***Youth Hostel & Archaeological Education
Centre (MP 06_0265 MOD 2)
110-128 Cumberland Street, The Rocks***

Director-General's
Environmental Assessment Report
Section 75W of the
Environmental Planning and Assessment Act 1979

November 2011

Figure 2: Southern Elevation

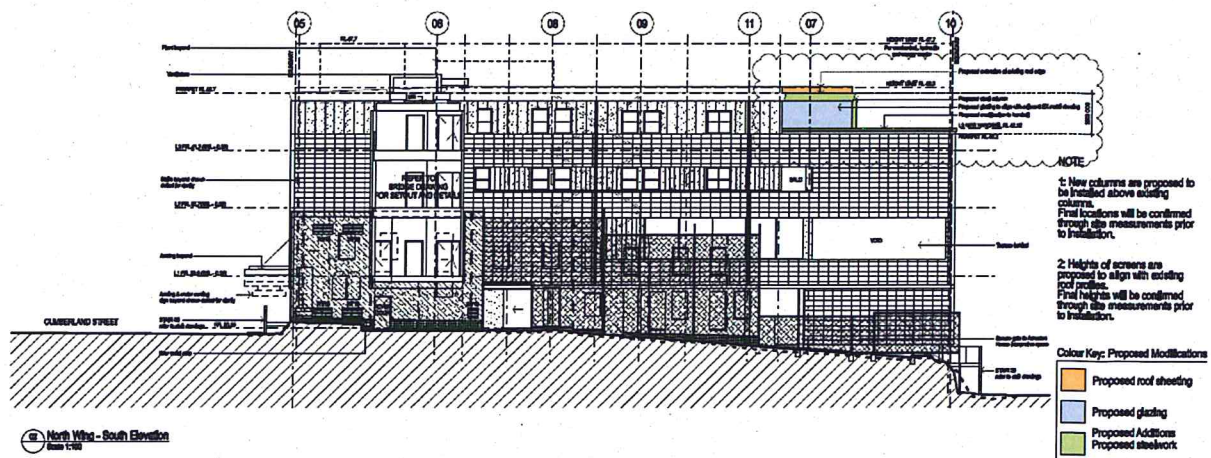
- increase the height of the balcony balustrade on the level 3 terrace by 200 mm (up to RL 42.52)
- extend the existing roof over the south-western portion of the level 3 terrace to create a 48m² pergola structure, with an overall height of 2.18 m (up to RL 45)
- install three glazed panels between the balcony balustrade and the roof of the pergola on the southern and eastern elevations.

Figure 7: Proposed view of subject site when viewed from the south-eastern side of Gloucester Street

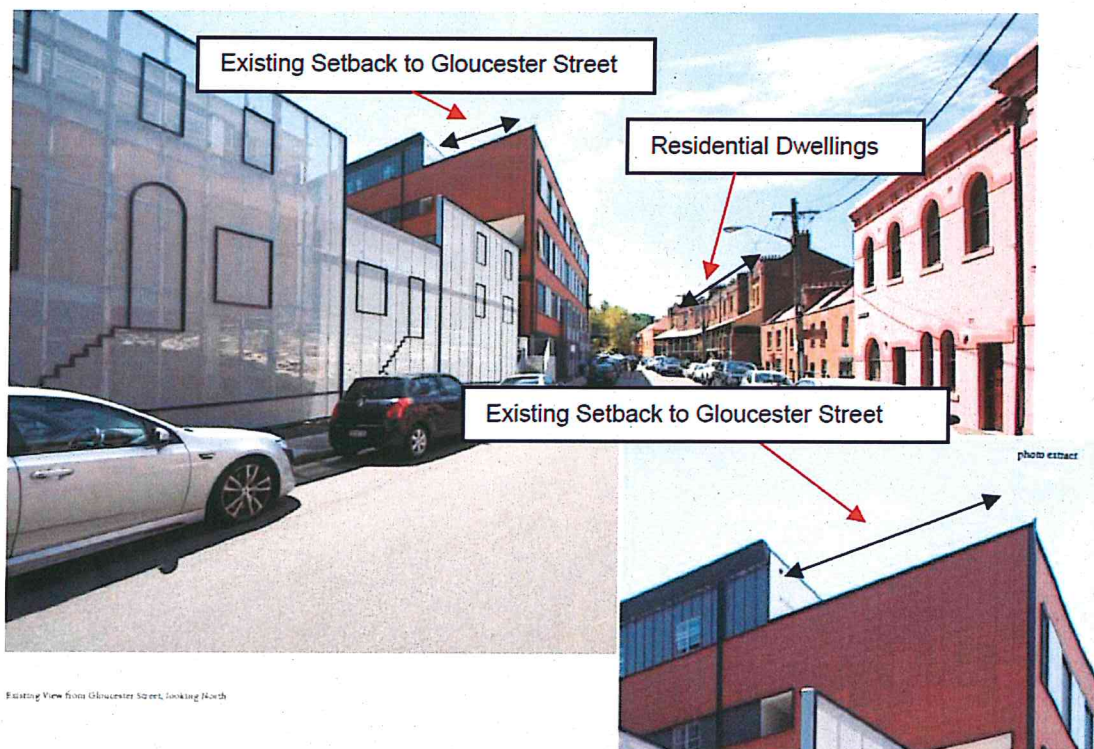
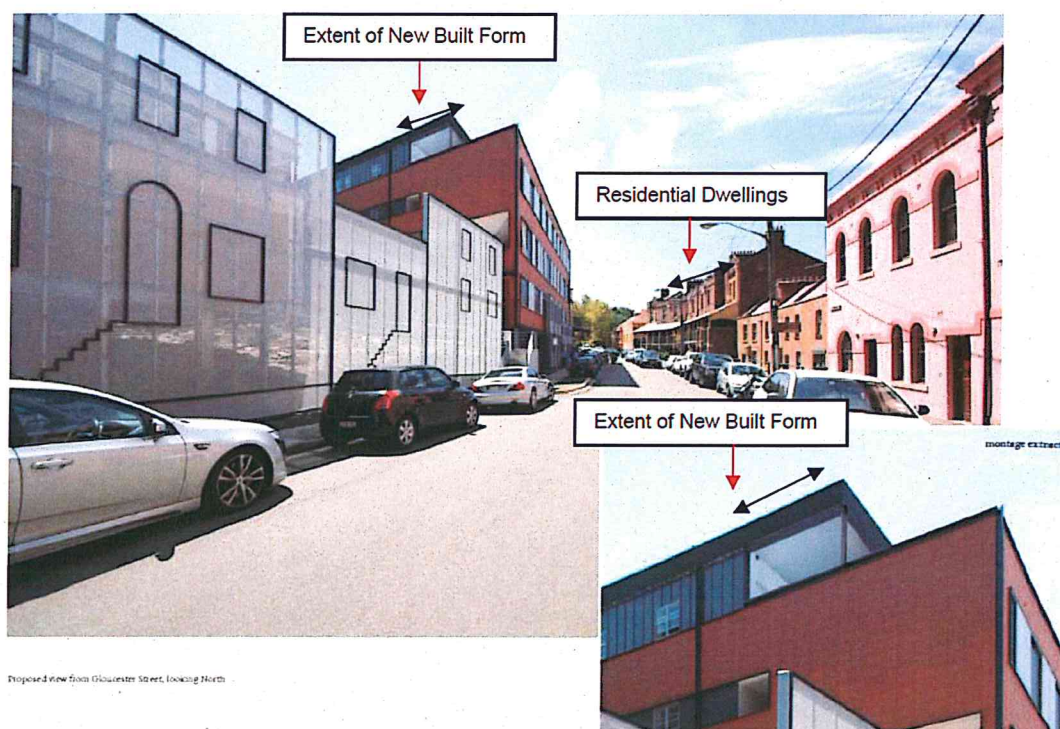
- The pergola would be visible along the south-eastern side of Gloucester Street (see **Figure 6** and **7** below). In order to reduce the visual impact of the proposal, the application seeks to incorporate materials that are currently present on the southern and eastern elevations to ensure a seamless transition between the existing and proposed development. The department considers this to be an appropriate design response.
- The proposed balcony balustrade would be a dark recessive colour (grey) and as such would not be discernable from the public domain.

- The pergola would not be visible from the residential dwellings to the north-west of the site along Gloucester Street and would not impede any views (see **Figure 7** above).
- The pergola would be visible from the commercial terraces to the south-east of the site at 85 Gloucester Street but would result in a negligible view loss given they are three-storeys below the height of the parapet of the pergola and there are no views to significant landscape or built features from the commercial properties.
